# **Response to the referee comment for article hess-2016-313**

**Note:** The text in black is the original comments from the referee, and the text in blue, headed with “Reply”, is the response from the authors.

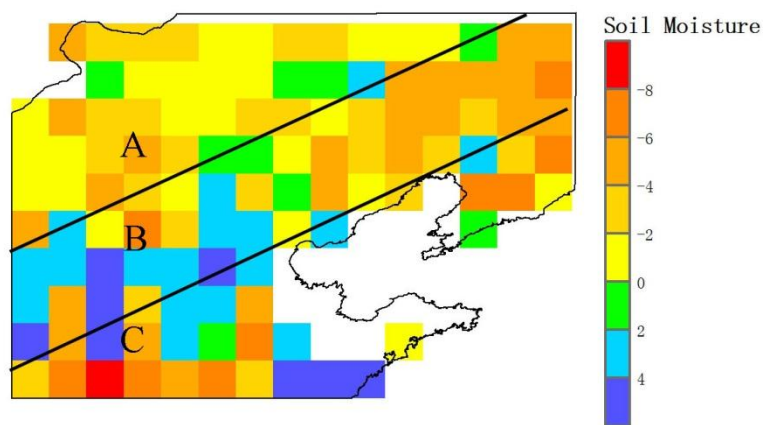
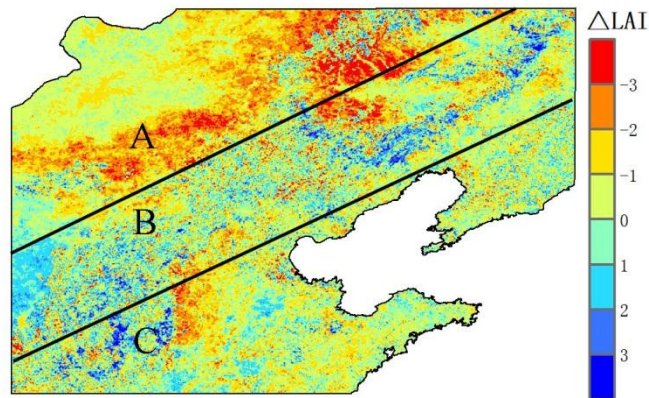
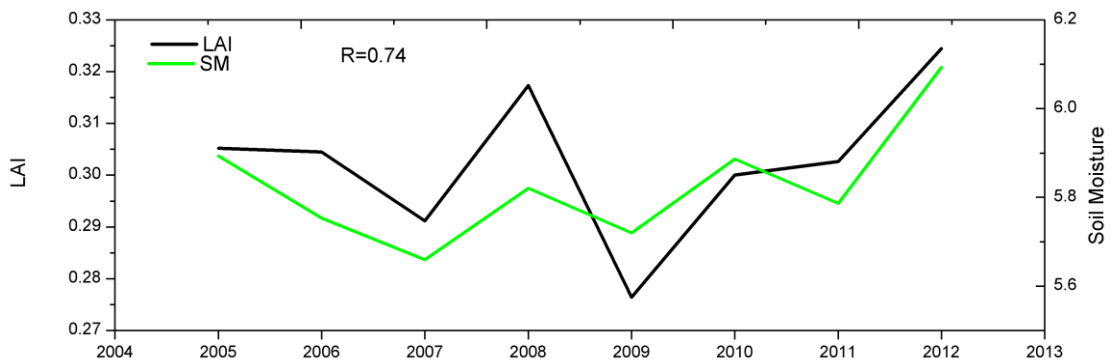
I cannot agree that the spatial distribution of the LAI reduction in Fig 11b is consistent with the area of water storage deficit in Fig 6.

**Reply:** Plant growth is more sensitive to soil moisture storage than the total water storage generally. So we analyzed the correlation of LAI with soil moisture in space and time. The relative reductions of LAI and soil moisture were calculated by

$$Red = \frac{V_i - V_c}{V_c} \quad (1)$$

Where *Red* is the relative reduction of LAI (or soil moisture),  $V_i$  and  $V_c$  are the average in 2009 and the climatology value for LAI (or soil moisture), respectively.

As shown in Figure 1 and 2, LAI and soil moisture have similar distribution in space. Both of them show significant reductions in the northwest of North China (Part A), but have minor increases in Part B. Their distributions are not so consistent in the

Southeast (Part C) where there are intensive human activities (e.g., crop cultivation and groundwater extraction). By and large, LAI and soil moisture storage show great reductions in the 2009/10 drought event.

Figure 3 presents the time series of the LAI and soil moisture during the plant growth season (May-October). We can see that the change of LAI agrees well with soil moisture in time, and their Pearson correlation coefficient is up to 0.74. Moreover, both of them reach the low points in 2009.

Therefore, the LAI reduction is consistent with the distribution of soil moisture to some degree in space and time. Vegetation growth is substantially constrained during the drought.
